LATIGO TRAILS - FILING NO. 9
LEGEND AND NOTES

LATIGO TRAILS - FILING NO.	9
WATER DISTRIBUTION PLAN	
SHEET	7 OF 13
JOB NO.	25175.01

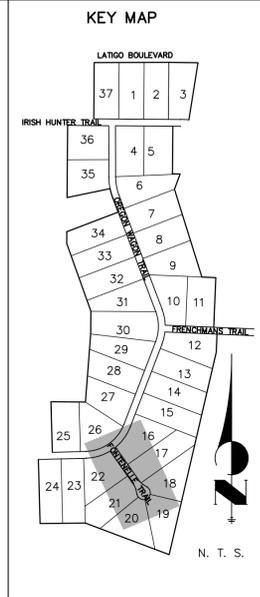
1. MERIDIAN SERVICE METROPOLITAN DISTRICT (MSMD) CONTACT TELEPHONE NUMBERS: **11886 STAPLETON DR FALCON, CO 80831 PHONE 719-495-6567**
- ~~ON-SITE OFFICE 719-495-6567. MANAGEMENT COMPANY, IN CARE OF CRS OF COLORADO, LLC 303-381-4965.~~

- ~~ALL POTABLE WATER, RAW WATER AND NON-POTABLE WATER VALVES 1 1/2" OR GREATER SHALL BE BUTTERFLY VALVES WITH A SIDE OPERATING NUT. THE OPERATIONAL DEPTH OF THE POTABLE WATER VALVES SHALL NOT EXCEED 6" IN OVERALL DEPTH NOR SHALL IT BE CLOSER TO THE SURFACE THEN 4"~~

**WP_03 PROFILE
 STA 1+00.00 TO 3+00.00**

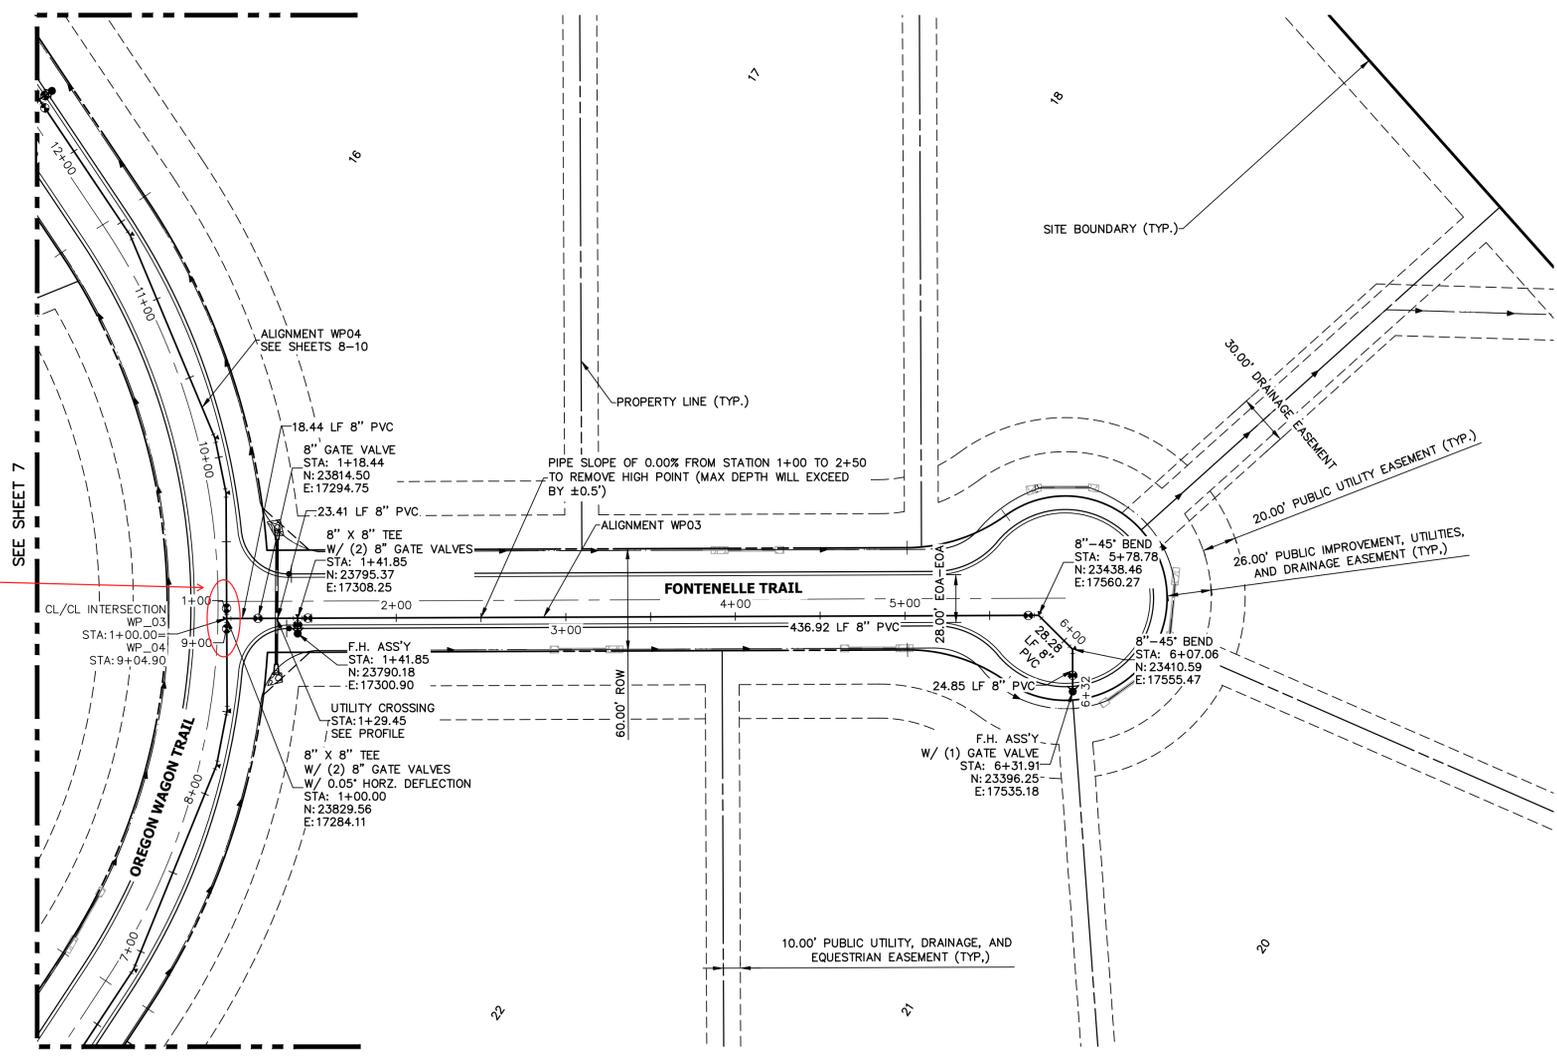
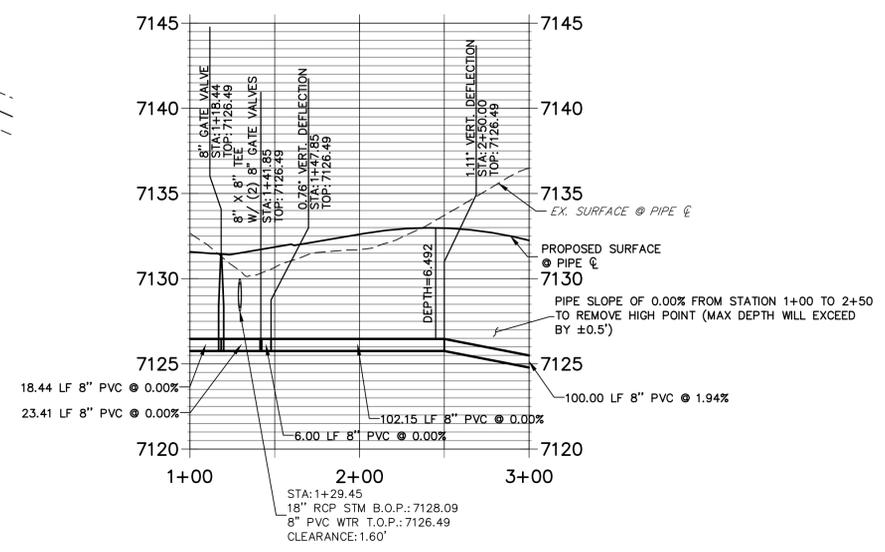
ELIMINATE ONE VALVE
